Consumer Product Service
Manager of Tehnical Support
TECH TIP

MODEL: ATARI CX5200

Defective Rockwell 6502 MPU on CX5200 PC Board.

PCB Retrofit to allow use of Atari VCSTTM Cartridge Adaptor

Figure 1. CX5200 Schematic (R-C Network)

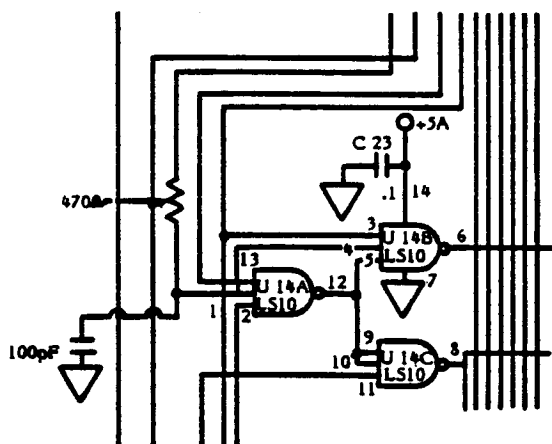
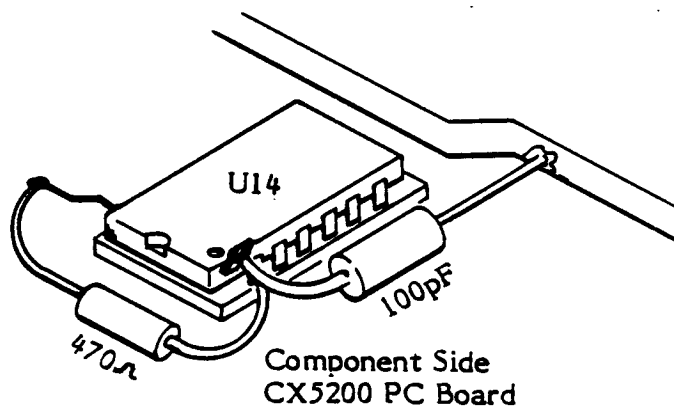
Rockwell MPUs with date code of 8250 and later (stamped with the letters RC) have a timing defect.

A factory modification adds an R-C network on the component side of the CX5200 PC Board at IC U14A (pin 1) and U6A (pin 4) (see Figures 1 and 2).

Figure 3. R-C Network (Add to solder side of CX 5200 PC Board)

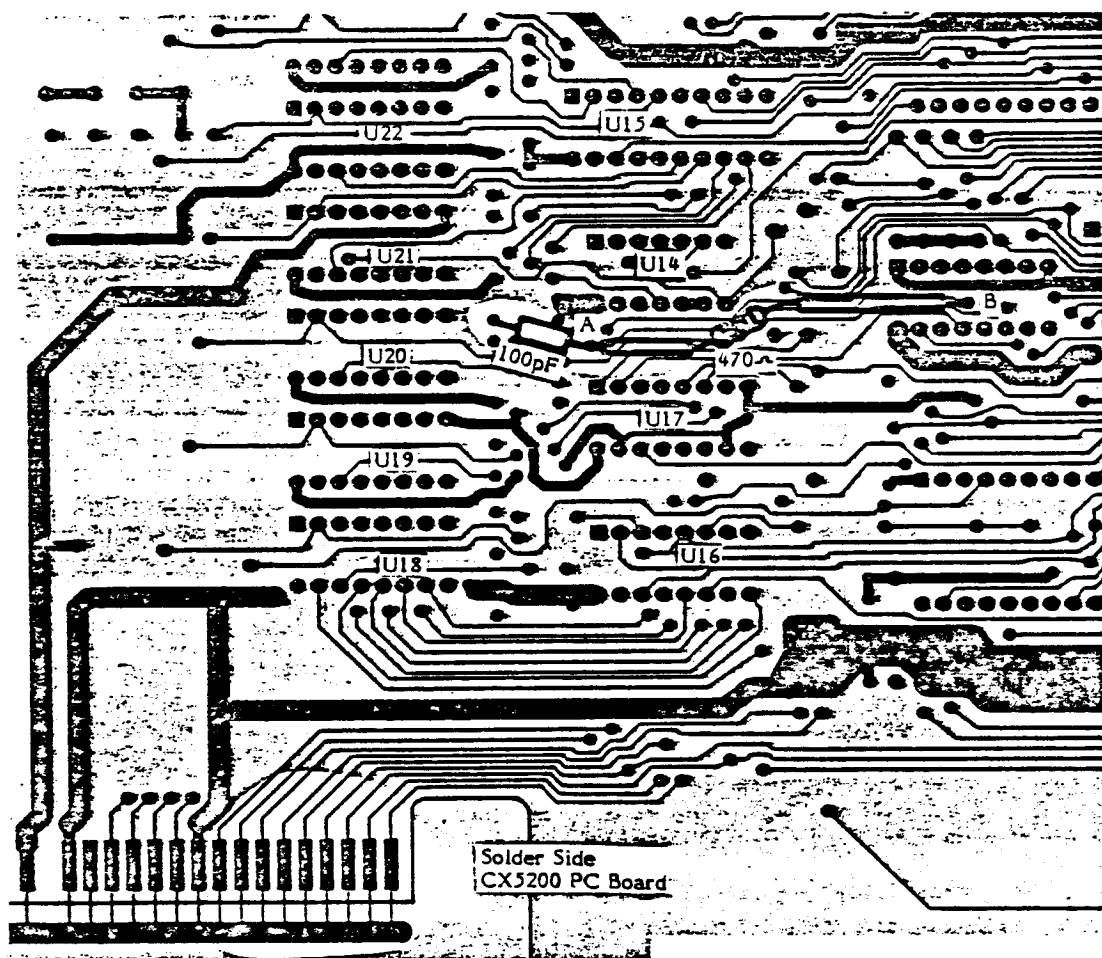
If you are installing an RC stamped 6502 on a CX5200 PC Board which has not had the factory modification added to the component side:

Add an R-C network to the solder side of the PC Board (See Figure 3).

1. Straighten the lead of C27 (solder side) and solder one lead of the 100 pf capacitor to it.
2. Point A is an unoccupied well between IC's U14 and U17. It is connected directly to Pin 1 of U14. Cut the trace running between points A and B as close to Point A as possible. Use a DVM to insure that the trace is now open.
3. Add sleeving to one lead of the 470 Ω resistor. Insert the lead into the well at Point A and solder.
4. Wrap the remaining lead of the 100 pf capacitor around the lead of the 470 Ω resistor at Point A and solder.
5. Remove the solder from well at Point B which is directly beneath U6. Add sleeving to the remaining lead of the 470 Ω resistor. Insert this lead into the hole at Point B and solder.

Old Top Controller Case

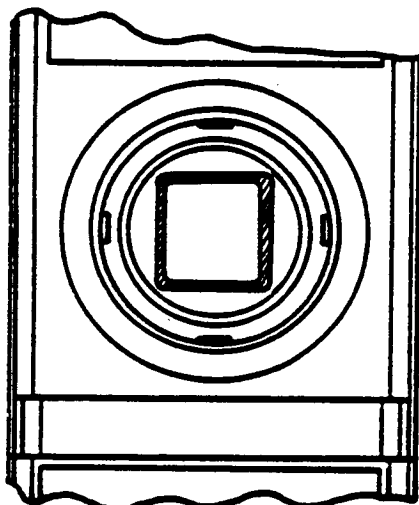
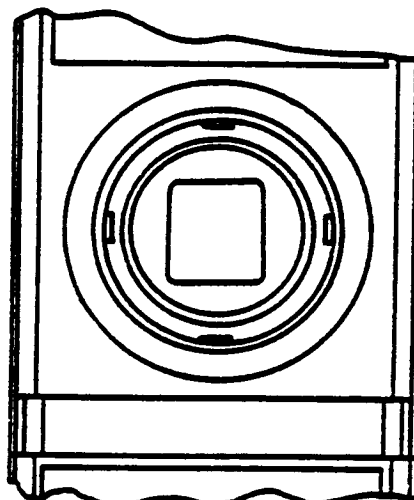
- 1) Follow Disassembly instructions for the CX5200 Controller in the CX5200 Field Service Manual.
- 2) Remove the top controller case and pull off the joystick handle.
- 3) Remove the boot retaining ring. Remove and discard the damaged boot.
- 4) If the top controller case contains the square ridge around the access well, as illustrated in "A" below, remove and discard it. Replace it with the new top controller case in which this square ridge has been removed, as illustrated in "B".

Figure 1. 5200 PCB Solder Side at J1

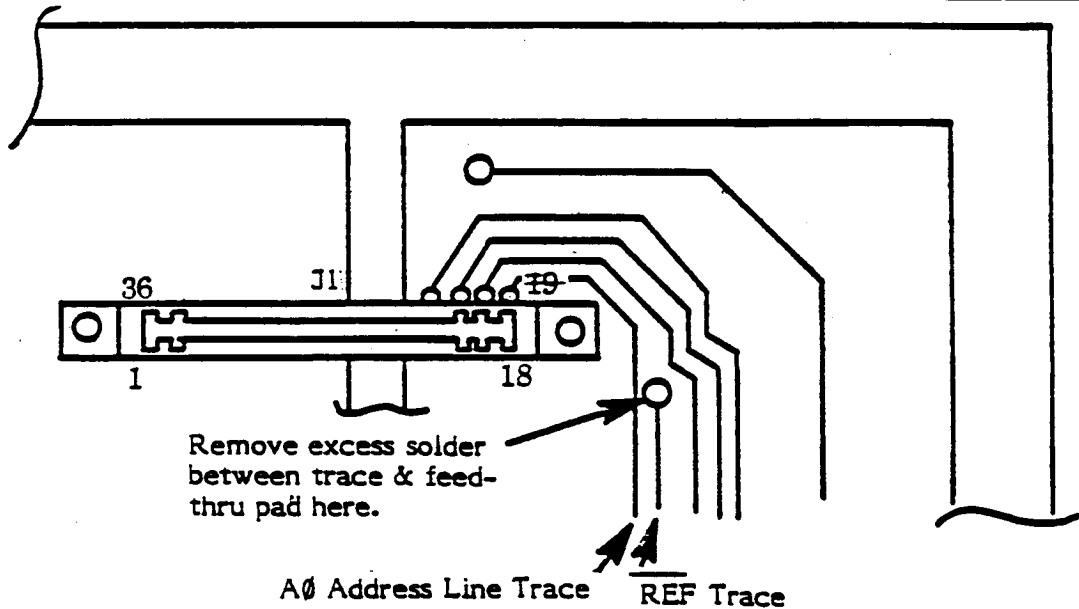
Some 5200 units display a blank dark screen or a screen with garbled information. The probable cause for either of these symptoms is an intermittent solder short (bridge) on the PCB between the A0 Address line trace and the feedthru pad of the REF Line trace (near connector J1).

- 1) Turn off power, and disconnect AC and interconnect cables.
- 2) Disassemble unit to expose the component side of the PCB (CA018087).
- 3) Locate connector J1, the adjacent A0 Address trace and the feed-thru pad of the REF Trace (See Figure 1).
- 4) Carefully remove the excess solder from the pad and wipe the area clean. Inspect the pad and if necessary use an X-acto knife to cut a shallow groove between the A0 Address Line and the feedthru pad. Be very carefully not to nick or cut the trace adjacent to the pad.
- 5) Reassemble and test the unit.

Figure 1. Resistor/Capacitor Fix

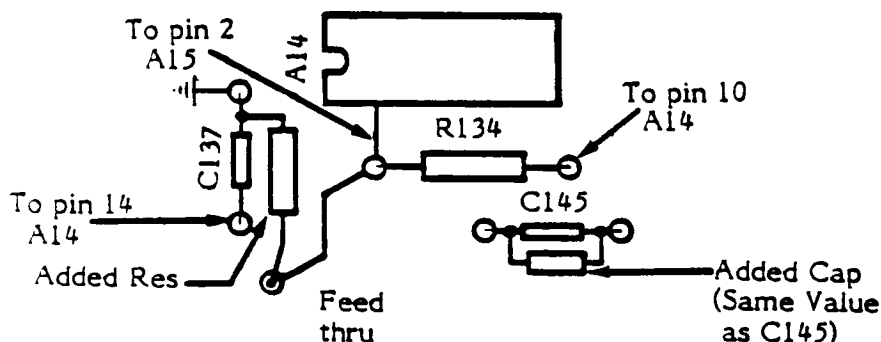
The timing of some Signetics I.C.'s causes RAM information to be distorted. This results in a scrambled screen display or worse - no video at all.

C145 (C014179-24) should be paralleled with another 390pf capacitor (C014179-24) and a 470 Ohm resistor (14-5471) be added from C137 to R134 (See Figure 1).

Figure 1. Sleeve Buss Wire Placement

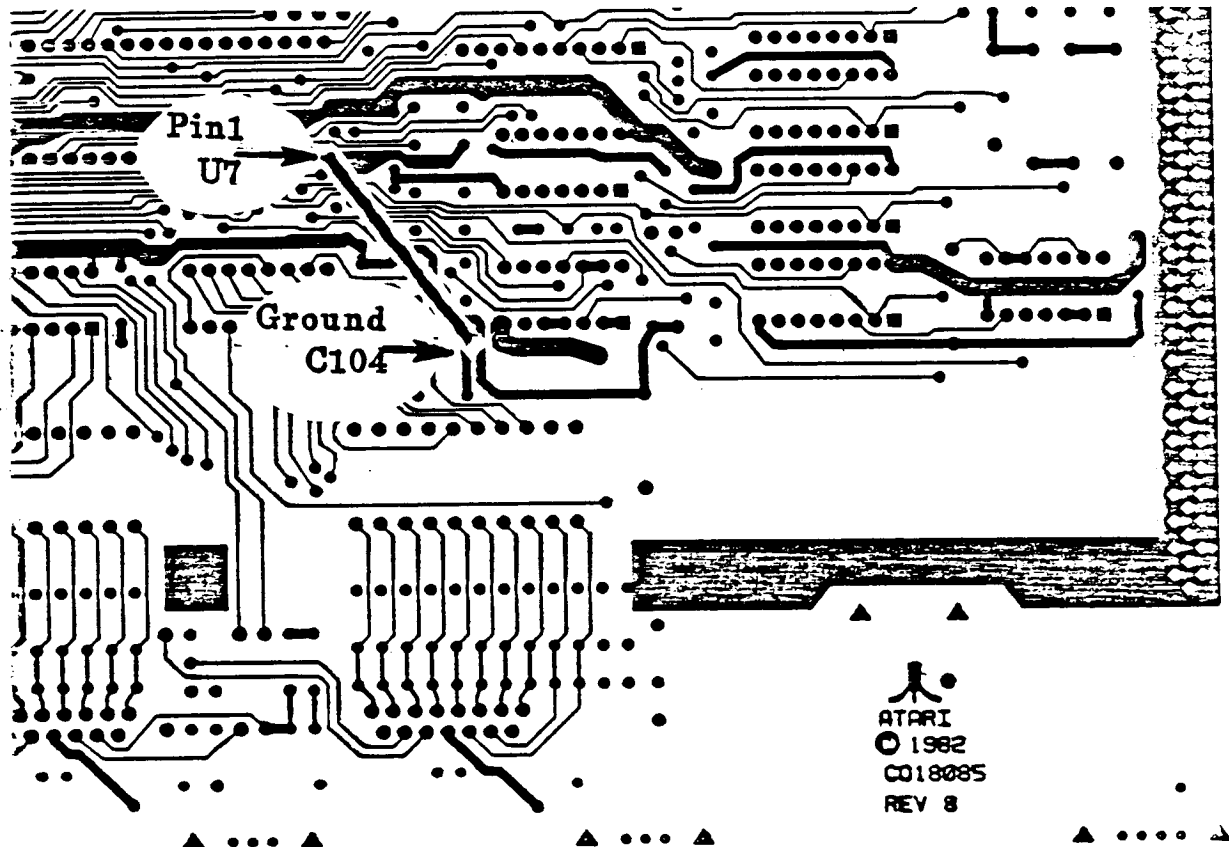
Some 5200 PCB's demonstrate paddle jitter caused by a ripple on the +5v power supply to the POKEY IC (U7), and an inadequate ground trace at Pin 1 of U7.

To eliminate paddle jitter a 10uf capacitor (C017516) must be soldered directly across the +5v and ground legs (Pins 1 and 17) of U7. A sleeved jumper wire must also be connected between Pin 1 of U7 and another ground trace.

- 1) Trim Capacitor to an overall length of 1 5/8 - 1 3/4 inches.
- 2) Cover the capacitor leads with sleeving. Approximately 1/8 inch of the lead must extend beyond the sleeving for soldering.
- 3) Solder the "+" lead of the cap to Pin 17 of U7 (+5 volts). Solder to the I.C. Leg
- 4) Solder other cap lead to Pin 1 of U7 (ground). Solder to the I.C. Leg.
- 5) Cover 1 1/4 inches of buss wire with plastic sleeving leaving sufficient length at each end for soldering.
- 6) On the solder side of the PCB solder one end of the sleeved buss wire to Pin 1 of U7. See Figure 1.
- 7) Solder the other end of the sleeved wire to the ground lead of C104. See Figure 1.

Figure 1. Trace Cuts

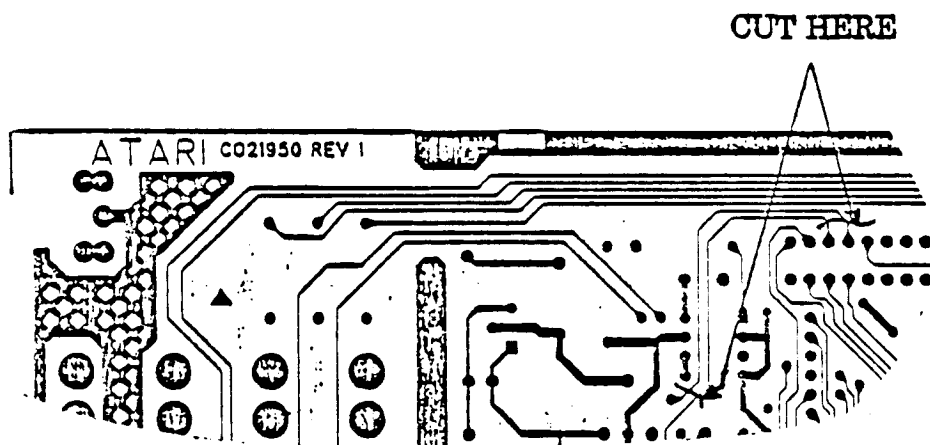
Screen jitters when Ms. Pacman is played.

On the solder side of the PCB, use two jumper wires to reroute traces between J1, Pins 15 and 16 and the data bus (See MODIFICATION PROCEDURES).

1. On the solder side of the Adaptor PCB, carefully cut the traces shown in Figure 1.

Figure 2. Jumper Wire Placement

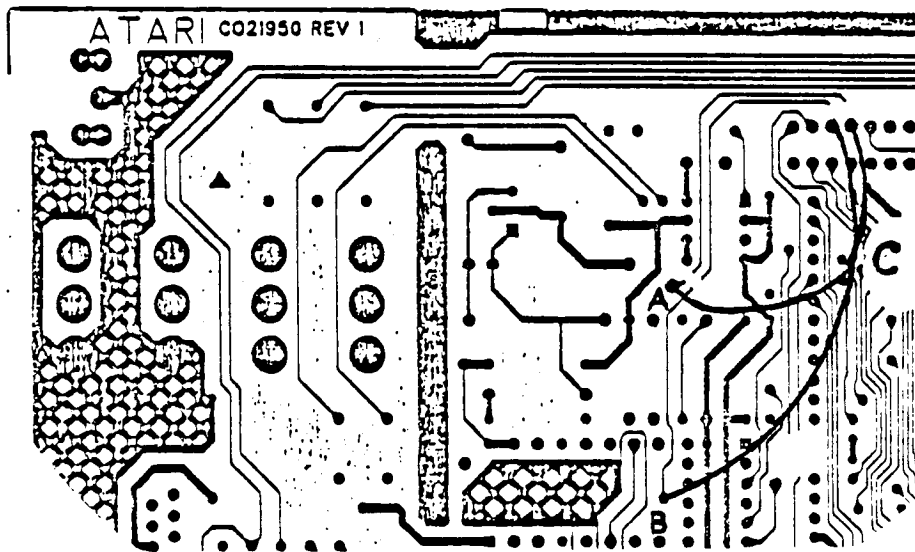
2. Wrap one end of the jumper wire around Pin 15 of J1, and attach the other end of the wire to the feed-thru identified as A in Figure 2 (below R9).
3. Wrap one end of another jumper wire around Pin 16 of J1, and attach the other end of the wire to the feed-thru identified as B in Figure 2 (near the ends of C12 and R14).
4. Use a non-conductive material and tack the jumper wires to the board. Tack the wires at locations identified as C in Figure 2.

Figure 1. Spacer Installation

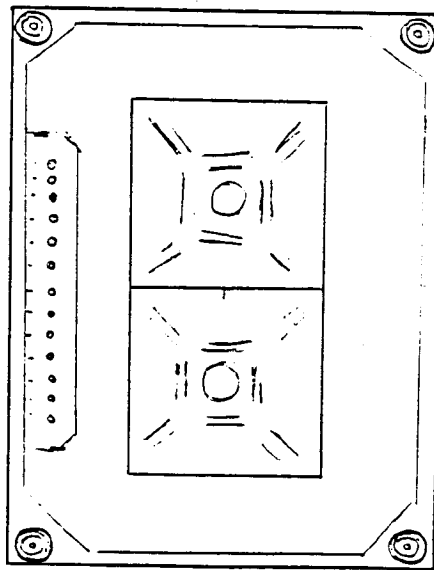
The backing of the telephone-style keypads used on the 5200 Retail Demonstrator have been breaking because of insufficient support.

- 1) Remove the four nuts and washers that hold the keyboard plate to the control panel.
- 2) Remove the keyboard plate.
- 3) Install spacers (see Figure 1).

Figure 1. Hole Cover Placement

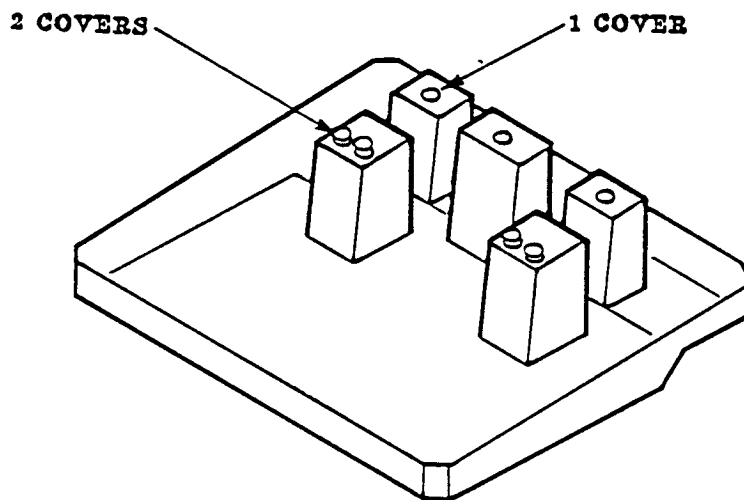
- 1) The metal domes under the fire buttons shift around under the mylar sheeting causing sporadic contact.
- 2) The 12-button keypad or the SELECT keypad slips under the top case.

Use eleven ATARI 810TM Disk Drive hole covers (C014106) and place them in the positions on the bottom case shown in Figure 1.

Figure 1. Pin 24 Isolation.

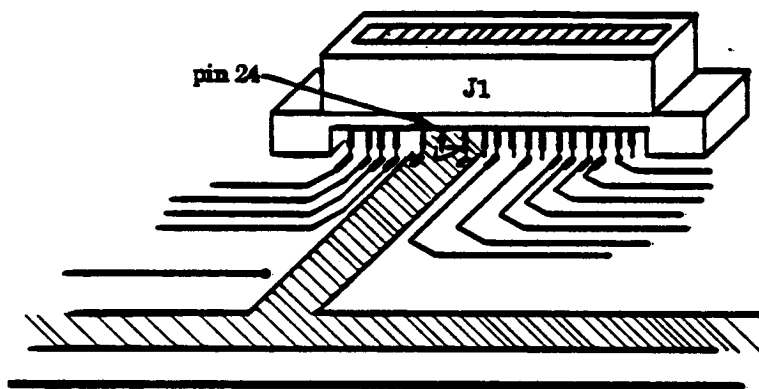
1. Remove the top cover of the CX5200.
2. Verify that the PCB Part Number is CA018087. (If it is not this number, there is no need for the modification. Reinstall cover, insert adaptor, go to step 13 and test.)
3. Remove both the top and bottom PCB shields.
4. Using either an X-ACTO knife or a Dremel tool (150 Bit), isolate Pin 24 of J1 from ground by making a "V" or "U" shaped cut in the trace on the component side of the PCB (See Figure 1). Be careful not to isolate Pins 23 and 25 from ground.

IT IS EXTREMELY IMPORTANT THAT PIN 24 OF J1 BE COMPLETELY ISOLATED FROM GROUND.

Figure 2. Pre-form Assembly

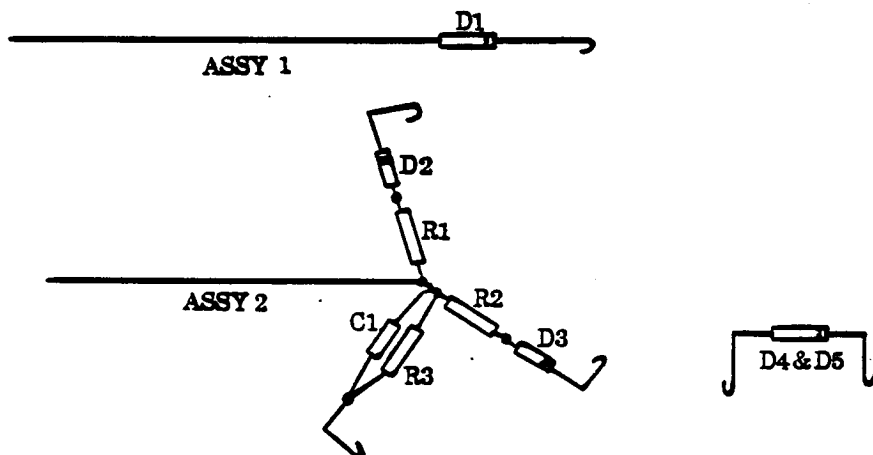
5. If the kit has not already been pre-formed (see Figure 2), use needle-nosed pliers and wire cutters to pre-form the kit. Use Figure 2 as a reference.

Figure 3. Retrofit Diagram.

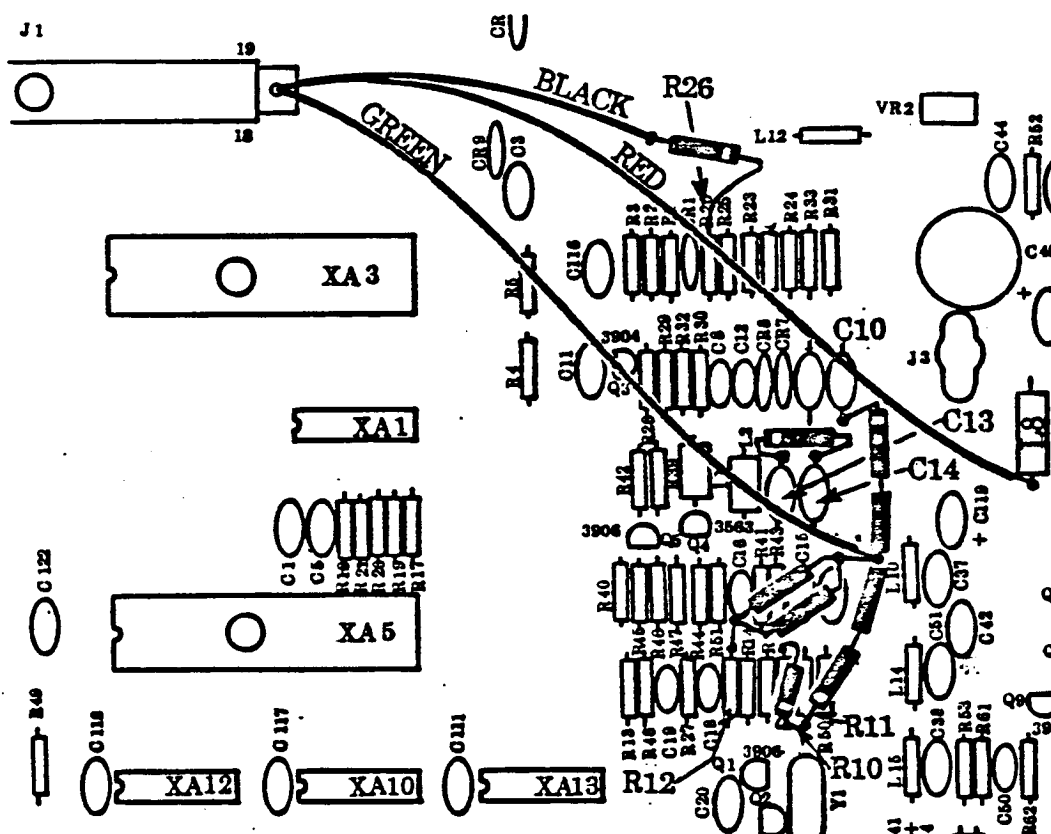
- A. Solder cathode of D1, Assembly 1 to R26.
- B. Pass Assembly 1 wire, (BLACK) through hole in J1.
- C. Solder cathode of D4, to C13.
- D. Solder anode of D4, to C14.
- E. Solder D5 to R10 (Note polarity).
- F. Solder cathode of D2, Assembly 2 to C10.
- G. Solder cathode of D3, Assembly 2 to R11.
- H. Solder R3, and C1, Assembly 2 to R12.
- I. Pass Assembly 2 wire (GREEN) through hole in J1.
- J. Solder one end of RED jumper wire to L8.
- K. Pass RED jumper wire through hole in J1.

Figure 4. Wire Connection Diagram.

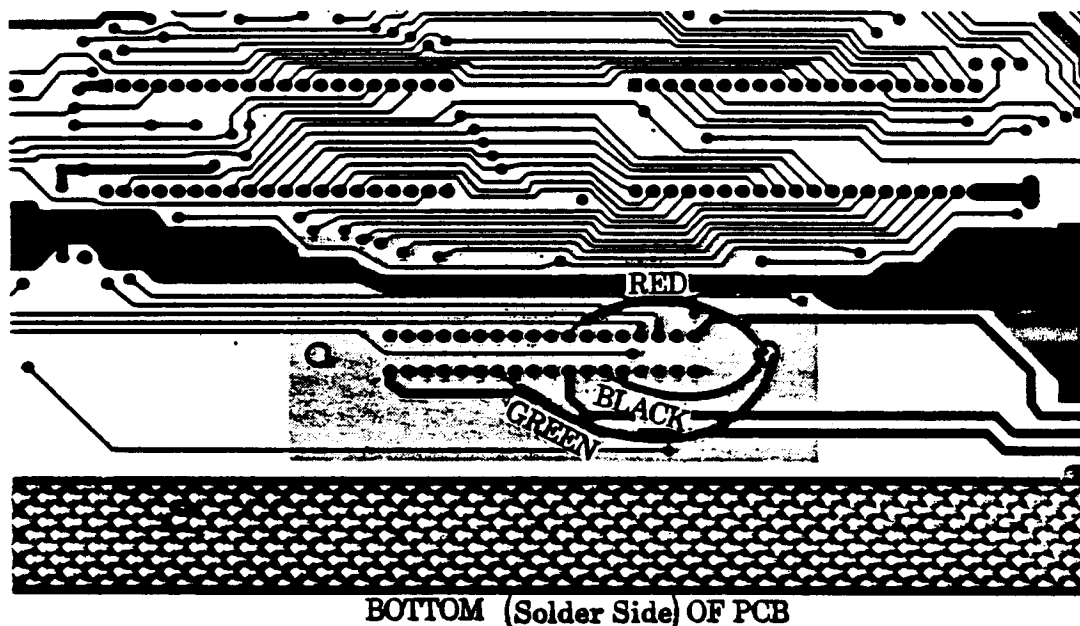
- A. Solder Assembly 1 wire (BLACK) to Pin 24 of J1.
- B. Solder Assembly 2 wire (GREEN) to Pin 30 of J1.
- C. *Solder RED jumper wire to Pin 11 of J1.

* = Take extra care to avoid connecting the RED wire to any ground pins. If the RED wire is grounded, the 5200 Power Adaptor will burn out.

Figure 5. Top Cover Pin Removal

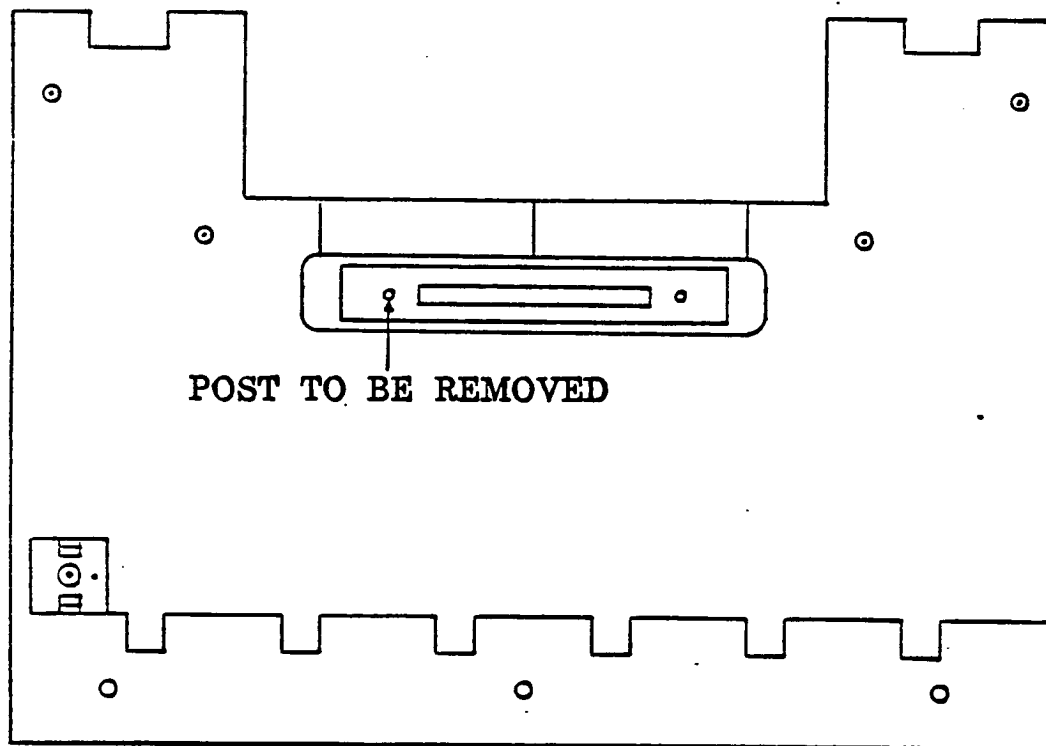
- 8. Place the top housing face down on the workbench.
- 9. Using needle-nosed pliers, grasp the pin indicated in Figure 5, and twist it off.
- 10. Before reassembling the unit, place the PCB into the bottom housing and replace the top housing. DO NOT SECURE HOUSINGS.
- 11. Using the 1.1 Diagnostic Cartridge perform a quick check to ensure that the modifications did not affect the performance of the unit. If the unit fails, return to the modification procedures, and make certain that all steps were fully and completely performed. The modifications will not affect game play or the unit's performance.
- 12. Turn off the unit.
